## Proposal Request

**PROJECT:** *(name and address)*  
AWSOM  
Bentonville, Arkansas

Architect's Project Number: 993A  
Proposal Request Number: 119  
Proposal Request Date: 03.18.2025

## Revisions to Kid's Nook

**2** CLINIC CHILDREN'S AREA  
1/4" = 1'-0"

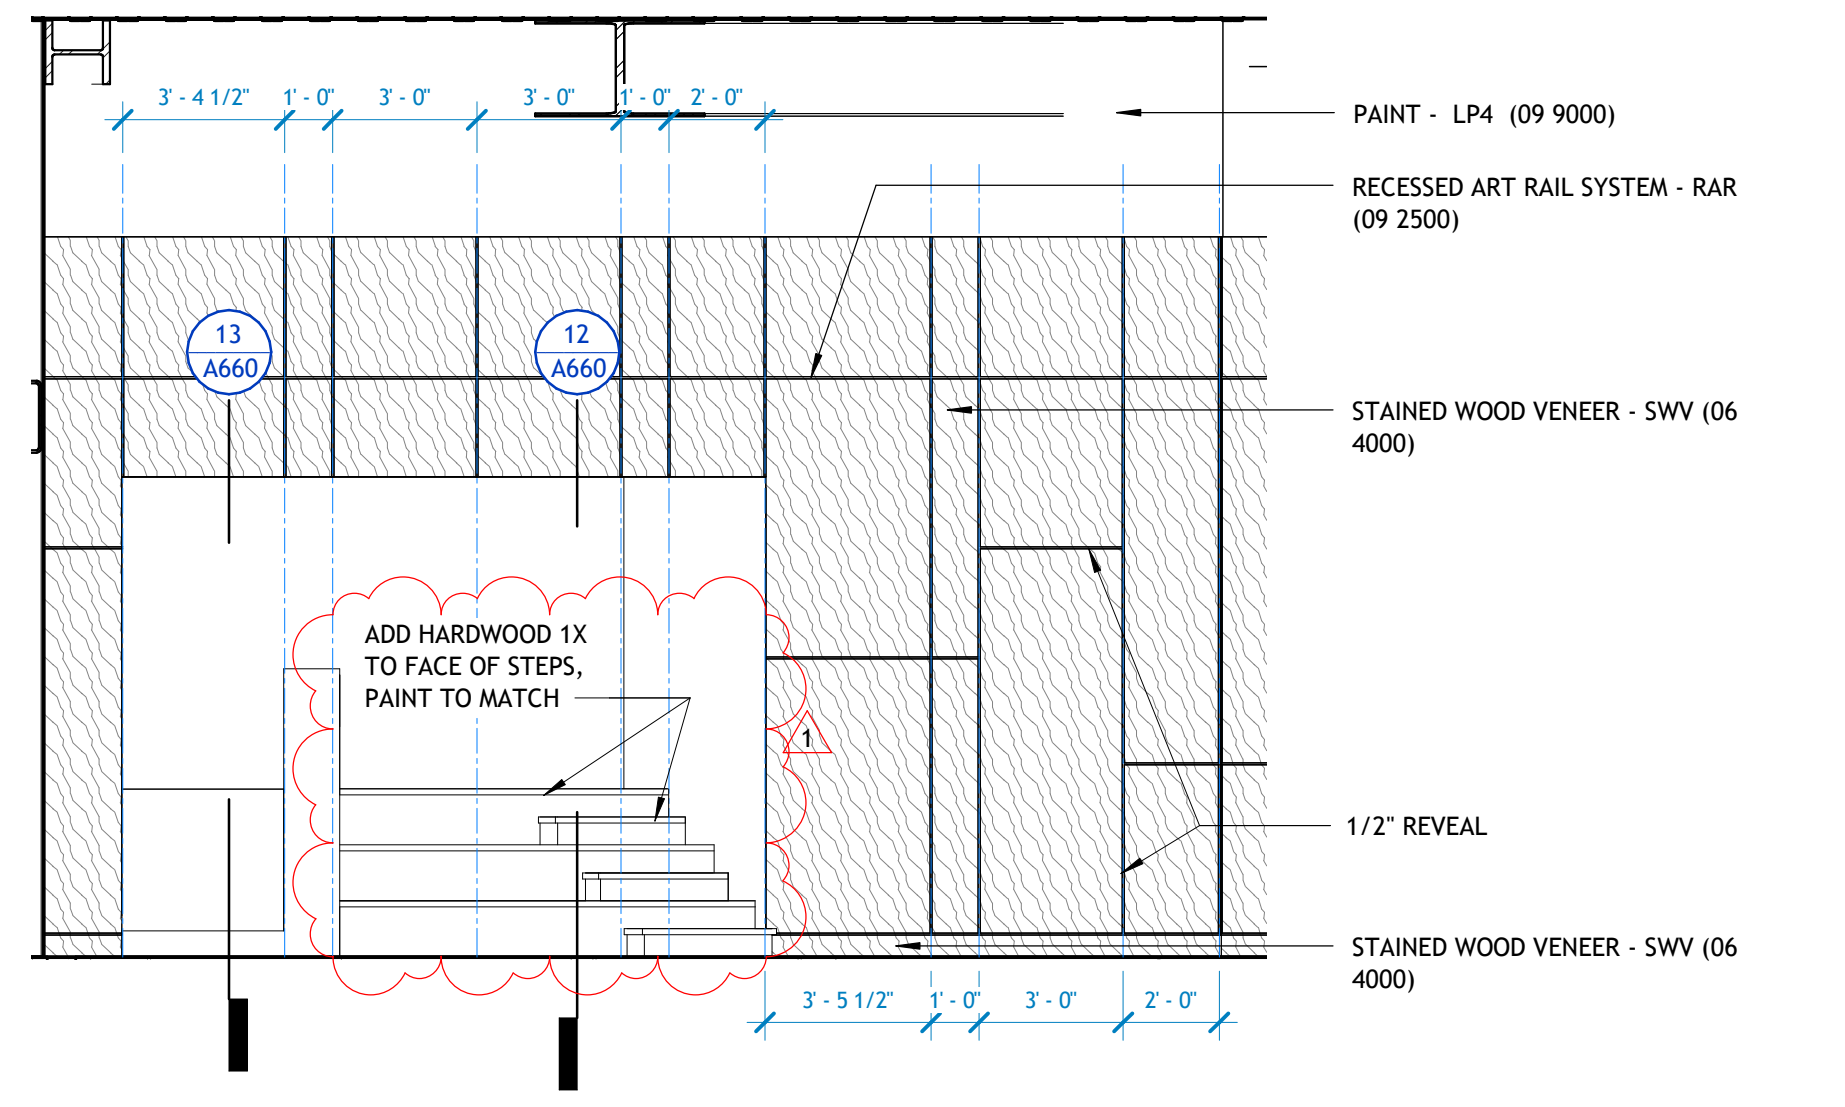
- a) Refer to Revised Sheet **A616**, with original issue date 02.24.2023 and revised date 03.18.2025.
  - Detail 2: Added hardwood 1X to face of steps as indicated in drawings. Paint to match surrounding area.
  - Detail 3: Added hardwood 1X to face of steps as indicated in drawings. Paint to match surrounding area.
- b) Refer to Revised Sheet **A660**, with original issue date 02.24.2023 and revised date 03.18.2025.
  - Detail 12: Added hardwood 1X to face of steps as indicated in drawings. Paint to match surrounding area.
  - Detail 13: Added hardwood 1X to face of steps as indicated in drawings. Paint to match surrounding area.
